TO: T10 Membership
FROM: Paul A. Suhler, Quantum Corporation
DATE: 1 December 2008
SUBJECT: T10/08-409r3, ADT-2: Internet ADT (iADT)

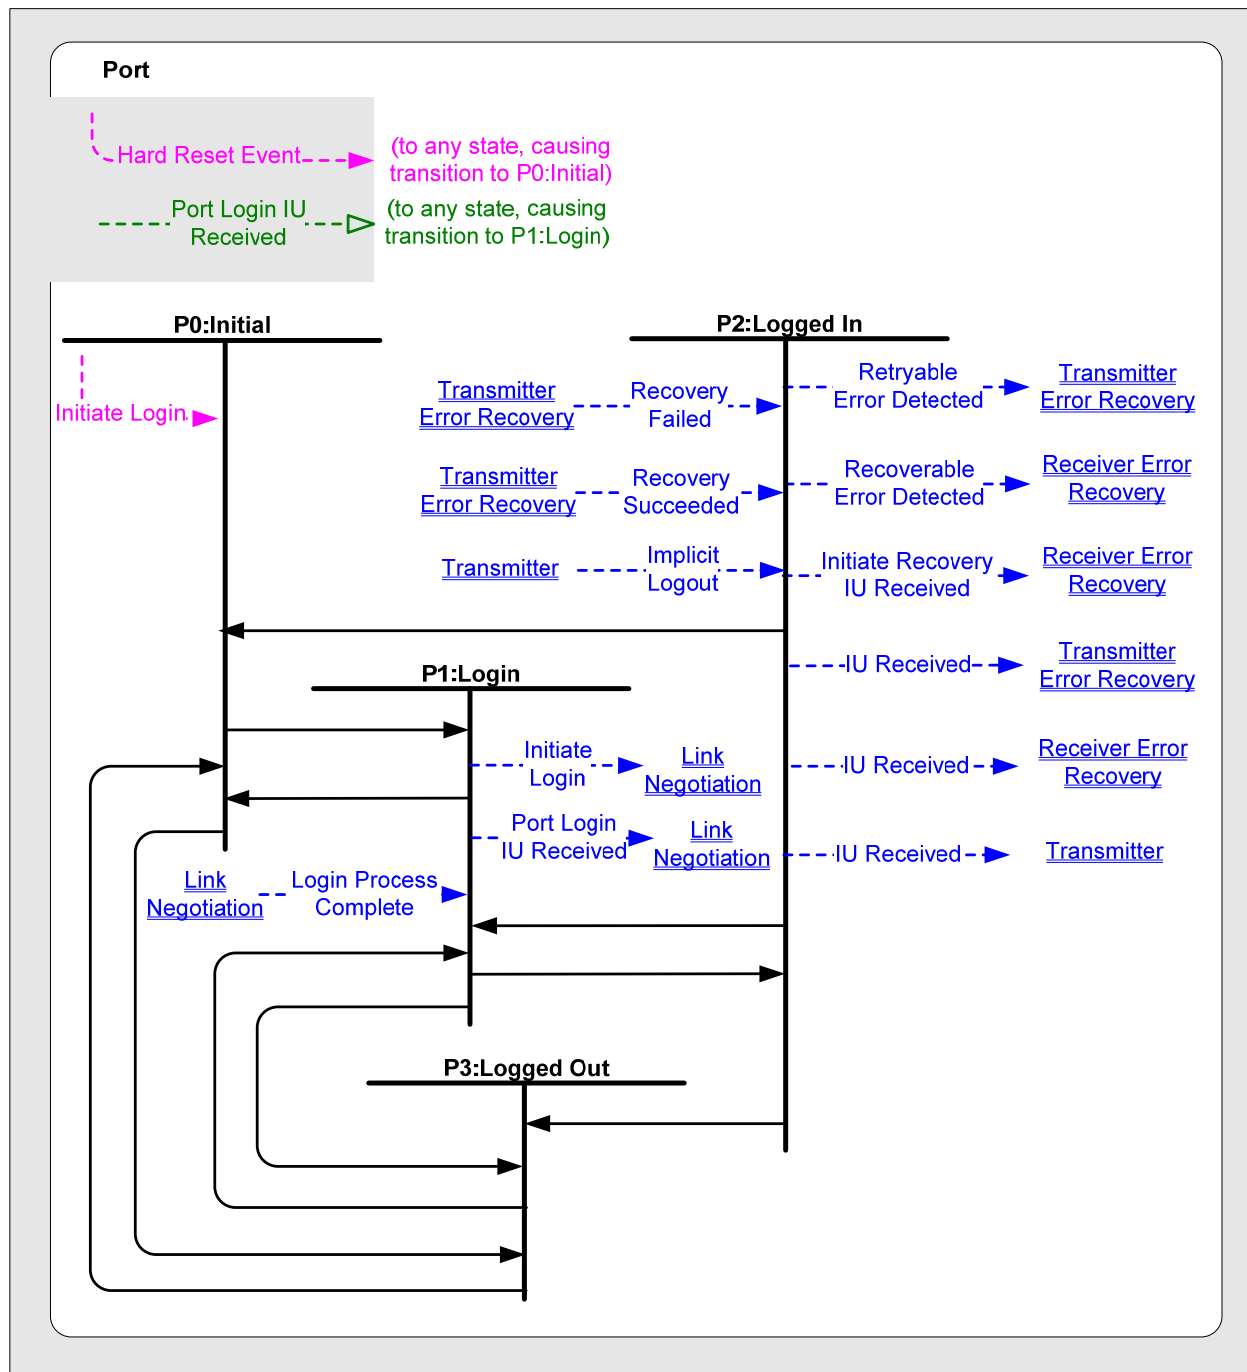
The ADT transport layer contains ~~five~~ **six** state machines to manage ~~a-connection~~ **sessions and connections** between two ADT ports. The state machines are as follows:

- a) port;
- b) link negotiation;
- c) transmitter;
- d) transmitter error recovery; ~~and~~
- e) receiver error recovery; ~~and~~
- f) **connection**.

The port state machine ~~is~~ **and the connection state machine are** the primary ~~machine~~ **state machines** and **are** always active. The other state machines are only active to manage specific operations (i.e they are sub-state machines of a state in the port state machine). **An ADT port contains one copy of each state machine for each session. The connection state machine only exists in the connection layer of iADT ports. The other state machines exist in the session layer of all ADT ports.**

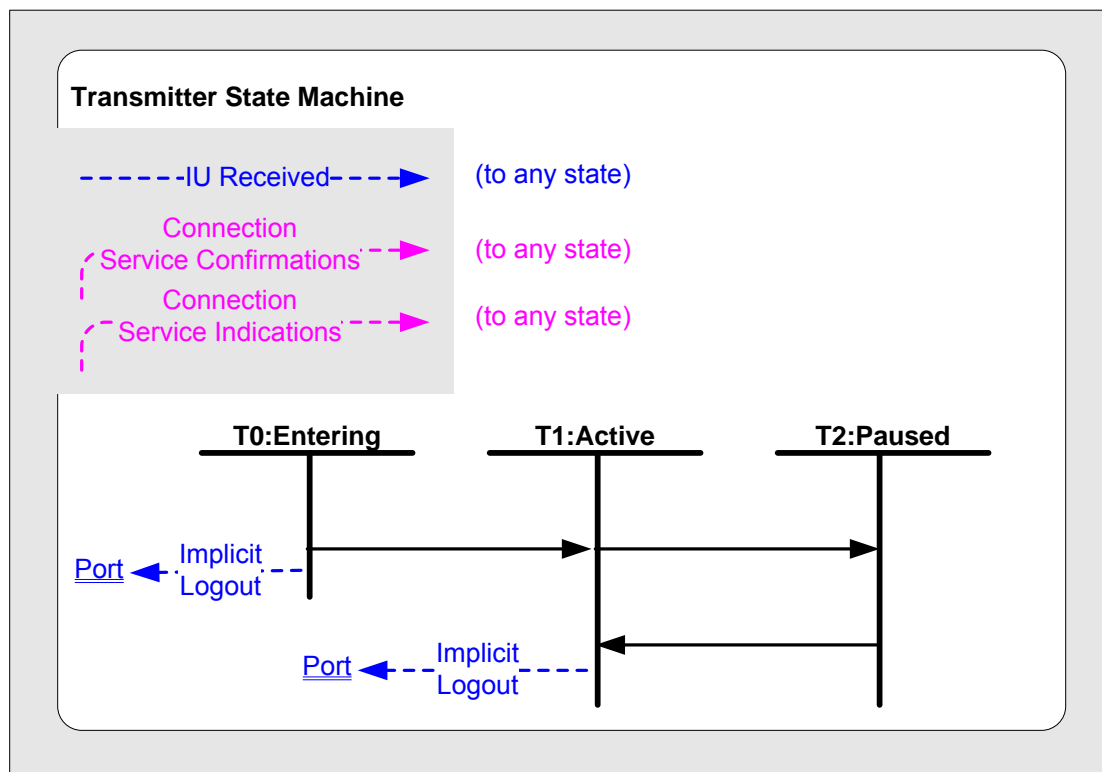
Add the Implicit Logout message to P2:Logged-In state in the Port state machine figure:

A port shall transition to P3:Logged-Out state after it receives an Implicit Logout message.

IBM Note: What timeout do we use or should we just go to P0:Initial?
Probably should be go to Logged-Out with timer of 0 (i.e., immediate timeout)
ADT-2 4.3.2.4.2 may need to be updated to go through logged out.
Initial or Logged-Out (i.e., like initiating or like receiving a Port logout)

Figure k – Connection State Machine Diagram

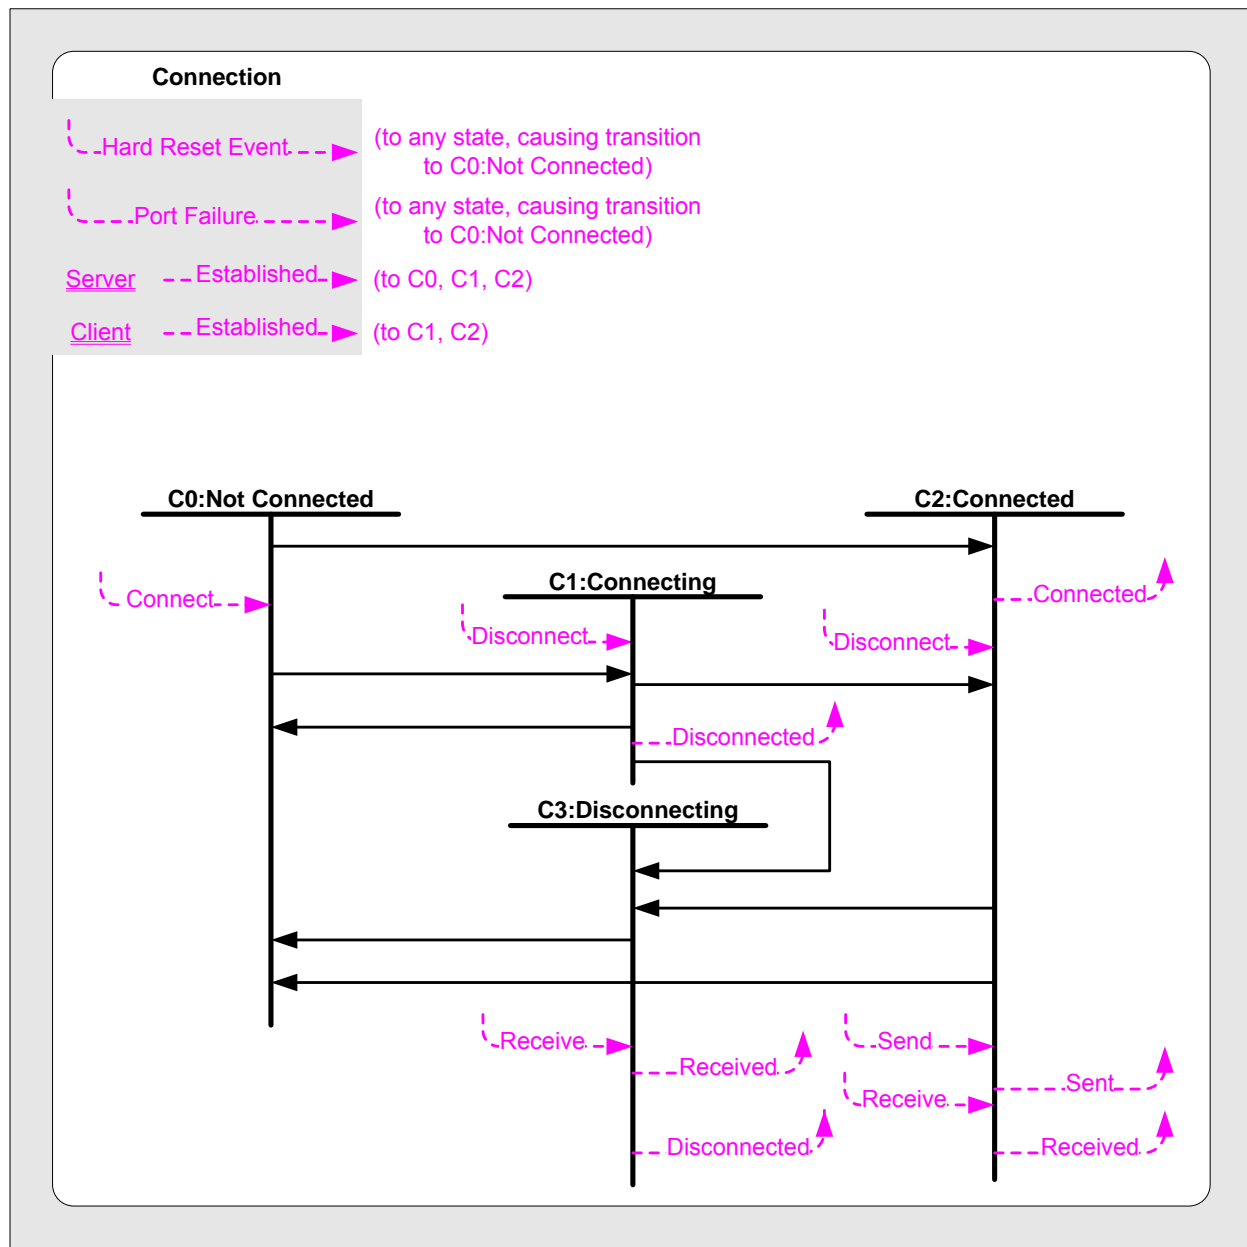
As long as we allow the local TCP port number not to be 4169, then there will be two separate connections, and thus one state machine for connections originated by the DTD and one for those originated by the AD.

Figure k shows the connection state machine. The following subclauses describe the transitions and the actions taken in each state. For a possible mapping of these actions to the Sockets API functions, see Annex D.
